ADDITIONAL PUBLIC INPUT

Please accept this letter as additional information to support the redistricting application for the proposed school site in NE St. Albert.

Suite 1700, 10130 – 103 Street NW
Edmonton, Alberta T5J 3N9
File No. 2018-045

FIGURE 2.1

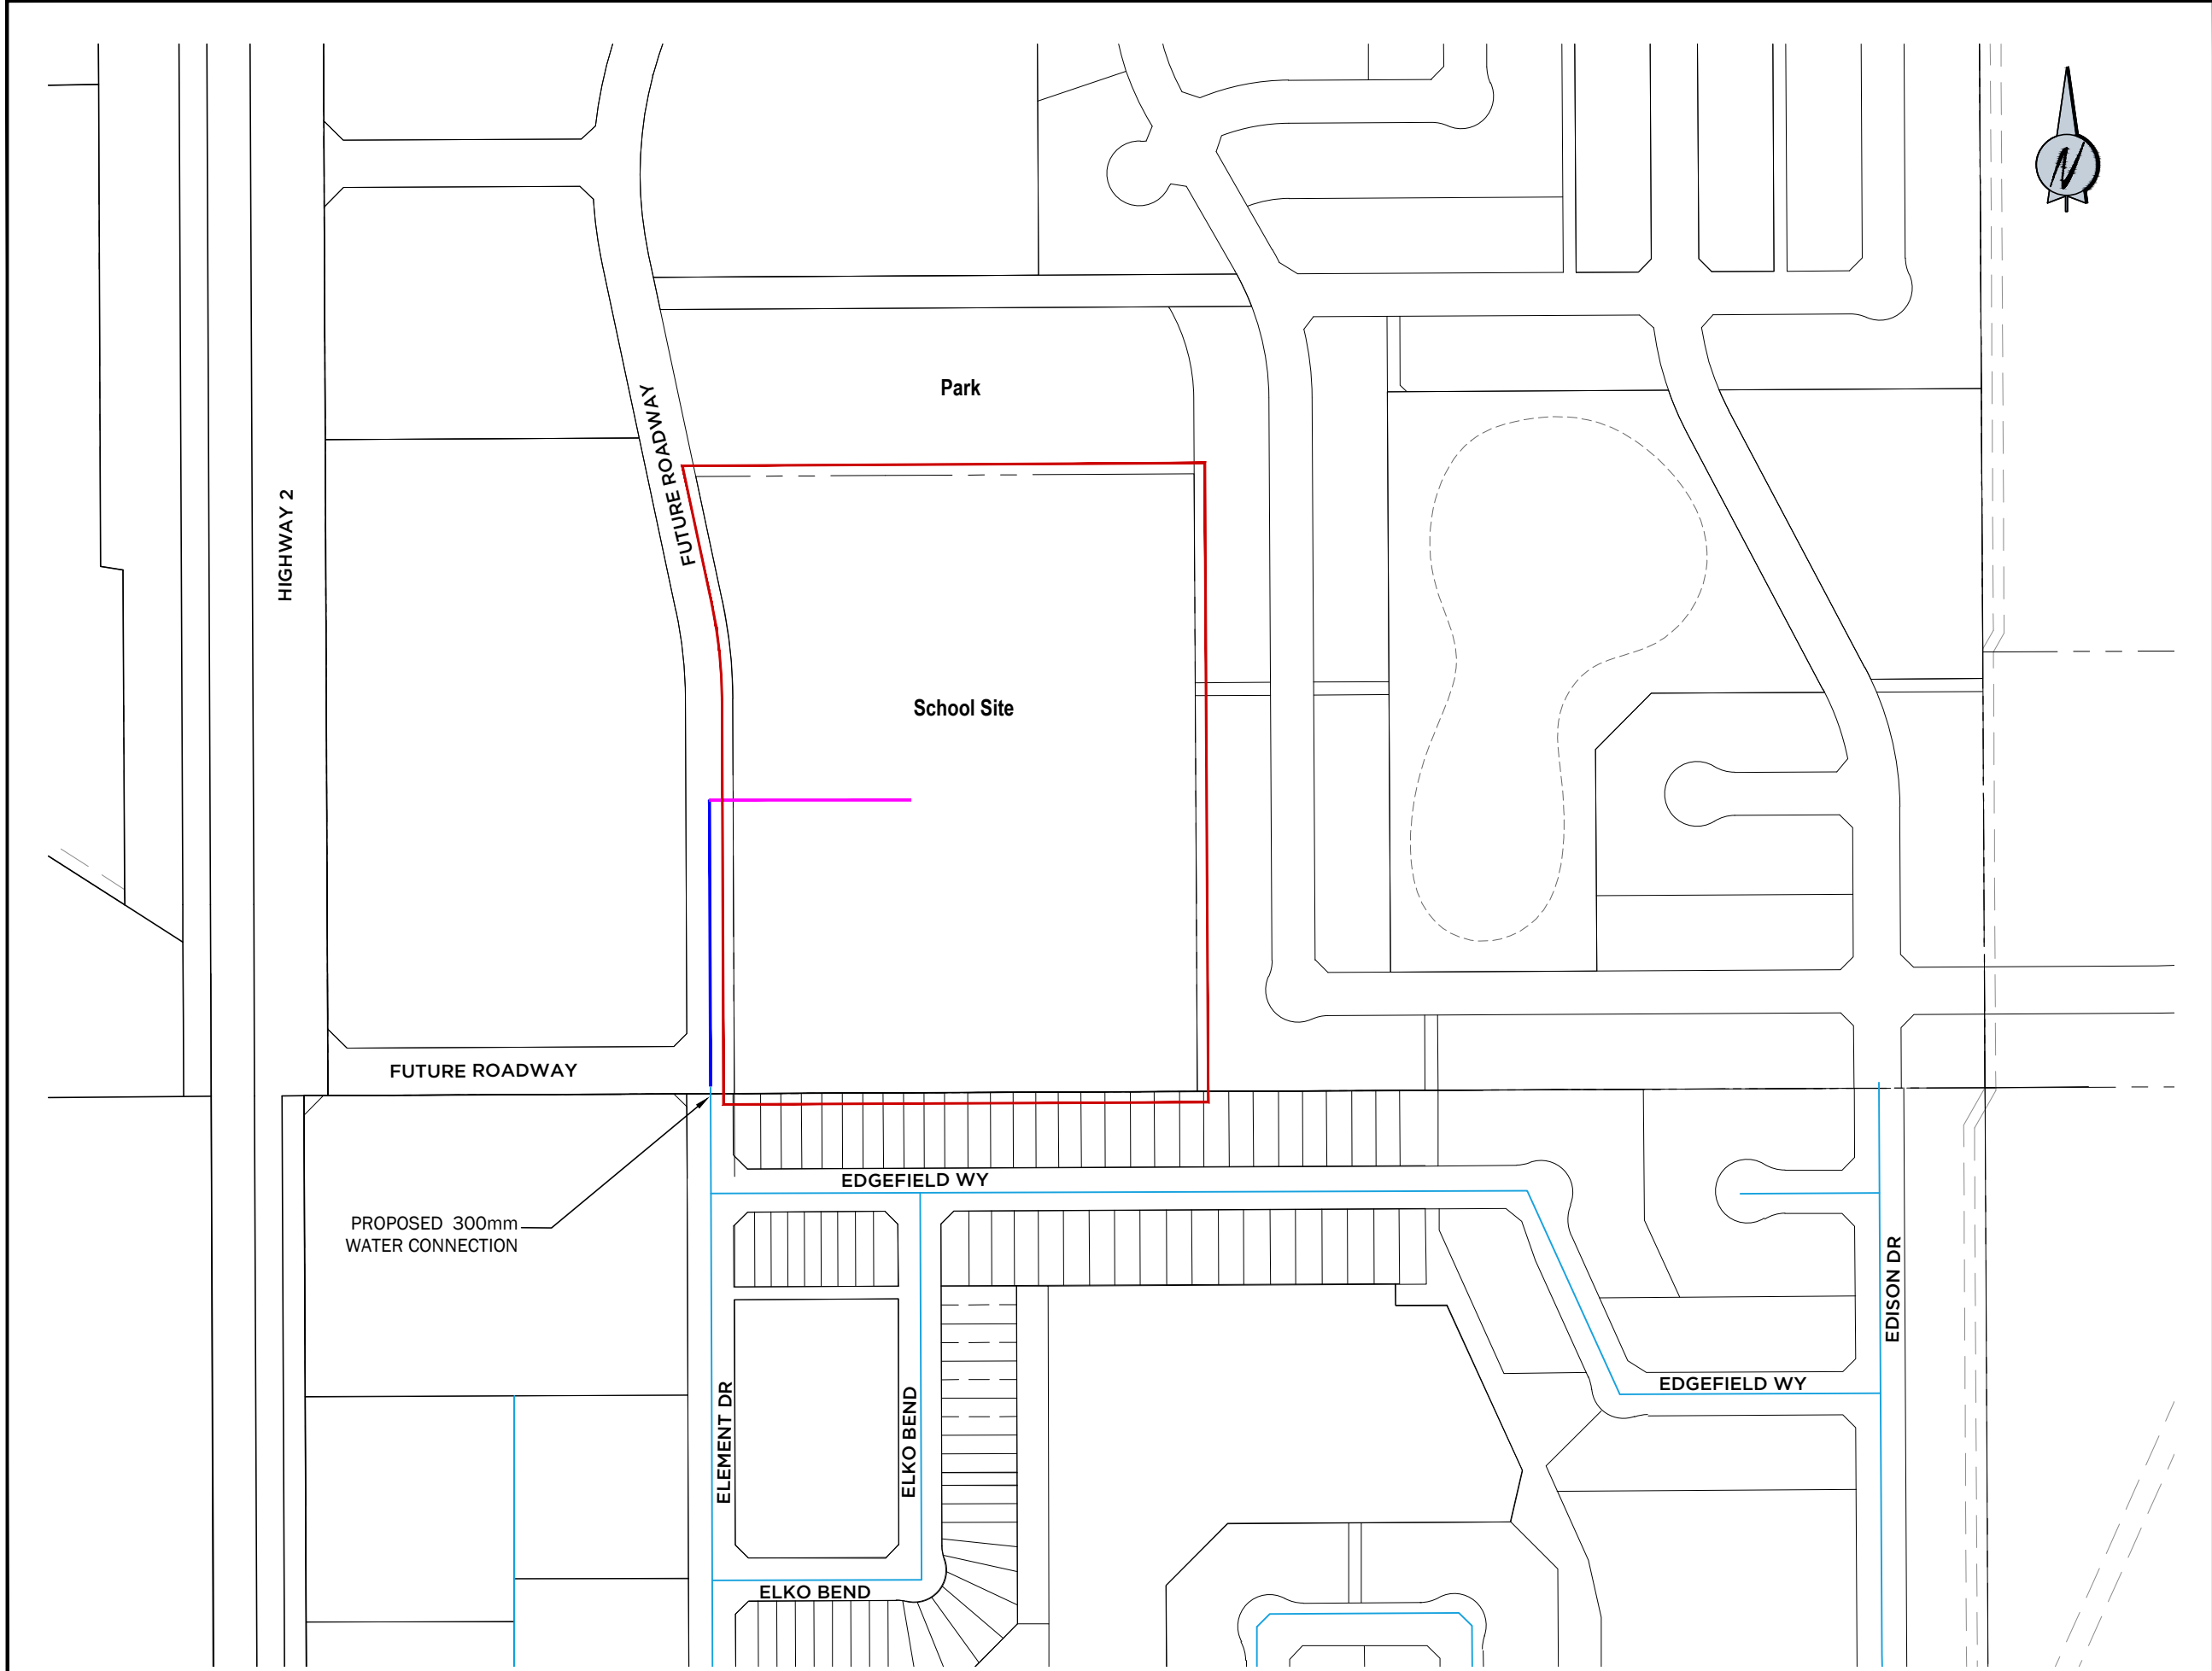
Water Servicing		
24	Fire flows will not be available in the interim and further analysis is needed at detailed design stage to understand what upgrades are needed. If interim upgrades are needed	Water Servicing	The costs for the on-site infrastructure should not be relevant to the redistricting of this site. The costs for the onsite infrastructure or upgrades to building materials are not required

The school site will require 300 L/s fire flow per the City of St. Albert Municipal Engineering Standards (November 2021). Previous analysis done at the ASP level and preliminary results for the NP stage suggest this fire flow will be available in the ultimate, full build out water network. However, in the interim, until a certain level of upgrades has been completed within the existing system, fire flow for the site may fall below 300 L/s. This should be further analyzed during the detail design stage when the status of these upgrades is better known. Depending on the results of this analysis, there are two different options for servicing and fire protection of the site.

If fire flow is found to be sufficient, no extra upgrades are required beyond extending the watermain as shown in *Figure 2.1*.

If fire flow is found to be insufficient, onsite private infrastructure/improvement to either boost fire flow, or reduce the required fire flow will be required (private booster station and/or reservoir, high fire resistance building materials).

FIGURE 3.1
PROPOSED SANITARY SEWER PLAN
NE ST. ALBERT SCHOOL SITE
SERVICING REPORT

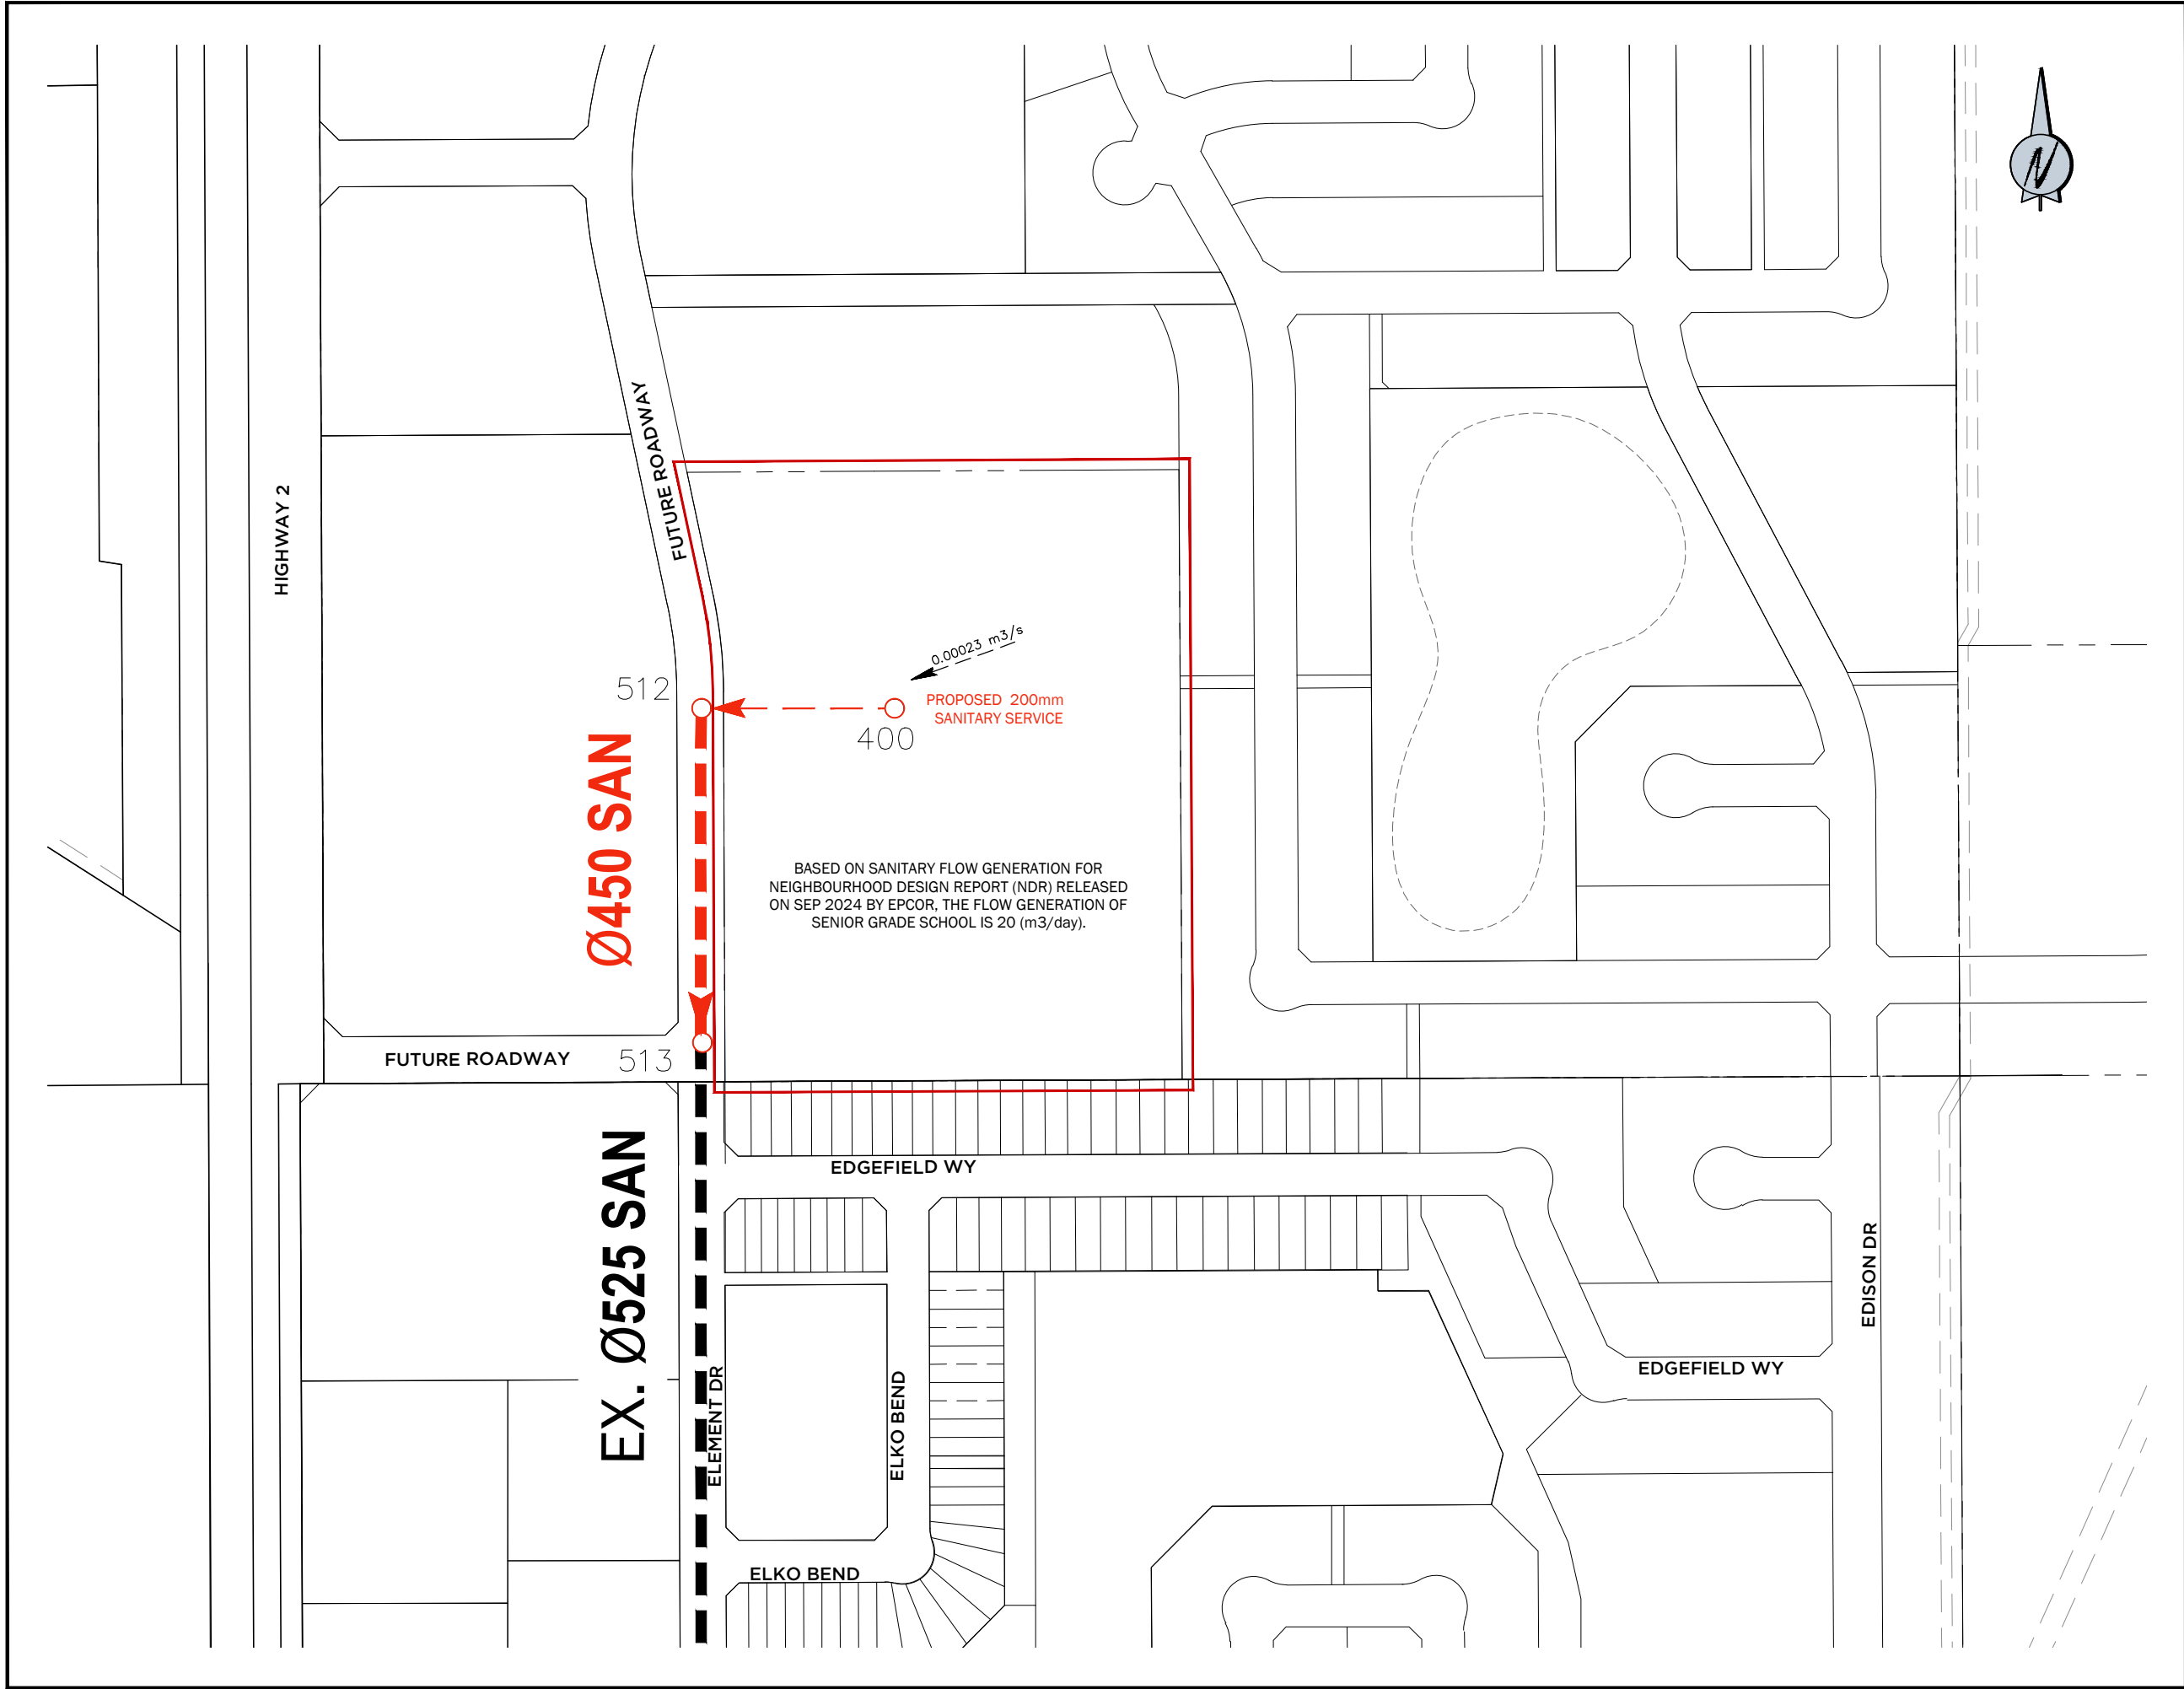
23	There remains a lack of capacity in the City's existing sanitary system that cannot accommodate any additional sanitary flows from new development. Administration and developers are exploring interim solutions for additional sanitary capacity in advance of the ultimate Northeast Servicing Project offsite levy project; however, no interim solution has been accepted by the City (as of the date of this report).	Sanitary Capacity	<p>Within the servicing brief for the school site, there is an opportunity for interim servicing. This servicing will allow for the site to conform to the ultimate design when the downstream NES projects are undertaken. The project team has been communicating these options as well as continuously working on addressing these through the Neighborhood Plan reports.</p> <p>The site where Future Fire Hall 4 is planned also contributes to the same sanitary system as the proposed school site. Alternate servicing methods were considered for that site to allow development to proceed.</p>

According to the approved NE St. Albert ASP Engineering Design Brief (May 2024), the sanitary MH 513 will be installed at the existing 525mm sanitary trunk plug location. The sanitary trunk will be extended north through the proposed neighbourhood roadway with 450mm pipes to upstream MH 512. The study area is ultimately intended to tie into the 450mm trunk through MH 512. Refer to *Figure 3.1* for a summary of the proposed sanitary sewer plan.
